Sentry 2X Battery Pack Schematic

6708 Sentry 2X Battery Pack

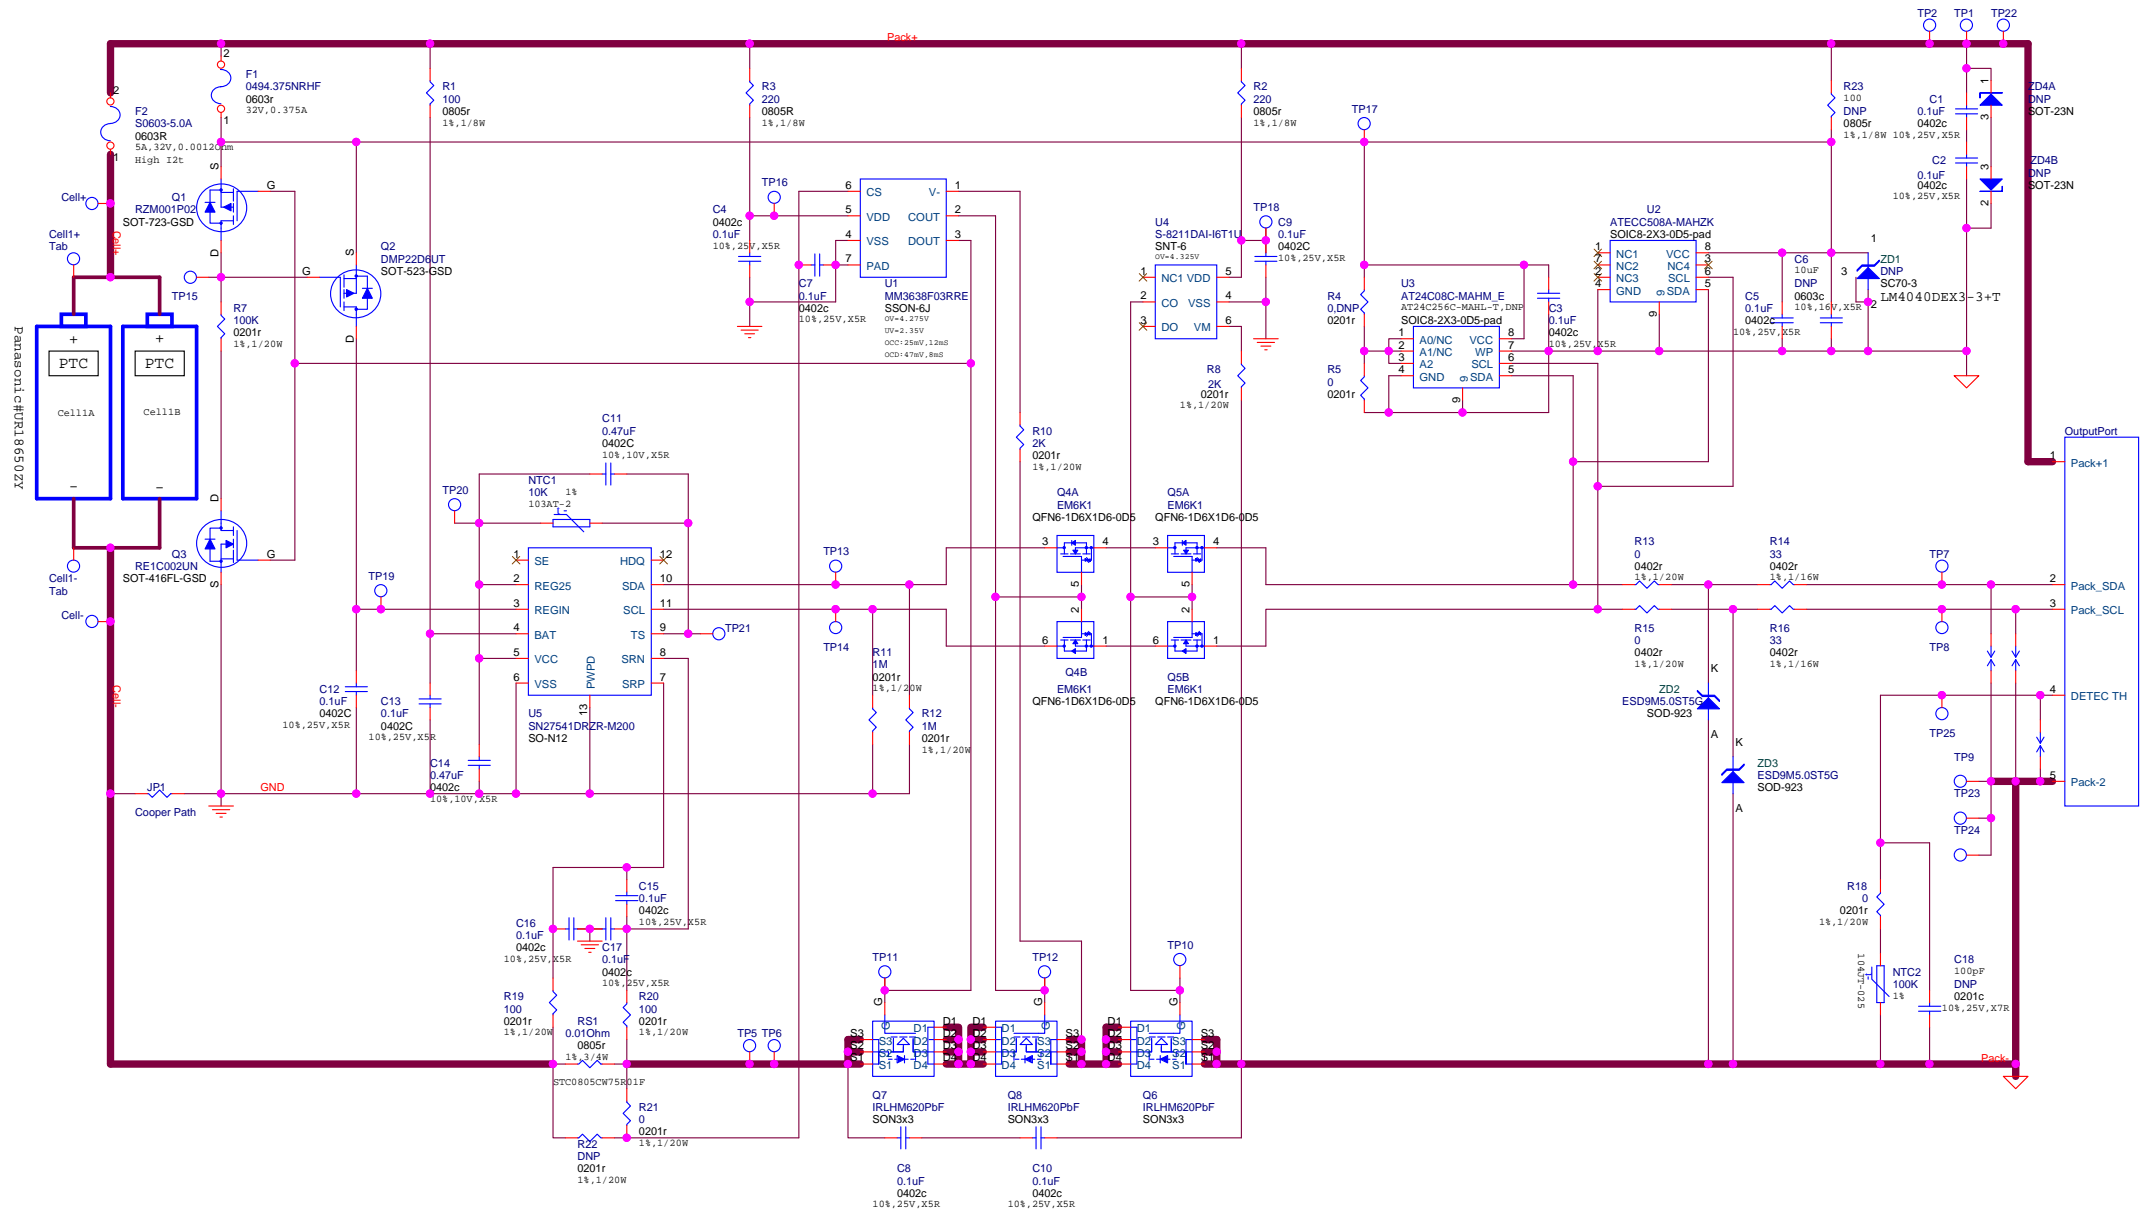
DATE	Change History	Issued By	Checked By	Approved By
2017/4/27	A1: New Release	Monkee Li	Jason Wu	XJJ
2017/6/19	A2: Change ZD2 and ZD3 to XGD10402, Add ZD3 NU. Change R11 and R12 to 1M and connection to GND. Change R14, R16 from 100 to 33. Change U3's address connection.	Monkee Li	Jason Wu	XJJ
2017/7/26	A3: Correct Caps Rating	Monkee Li	Jason Wu	XJJ
2017/8/10	A4: Update 0.1uF Caps Rating to 25V, Update ZD2, ZD3	Monkee Li	Jason Wu	XJJ

A1: New Release
A2: Change ZD2 and ZD3 to XGD10402. Change R11 and R12 to 1M and connection to GND. Change U3's address connection.
A3: Correct Rating
A4: Update 0.1uF Caps Rating to 25V. update ZD2, ZD3
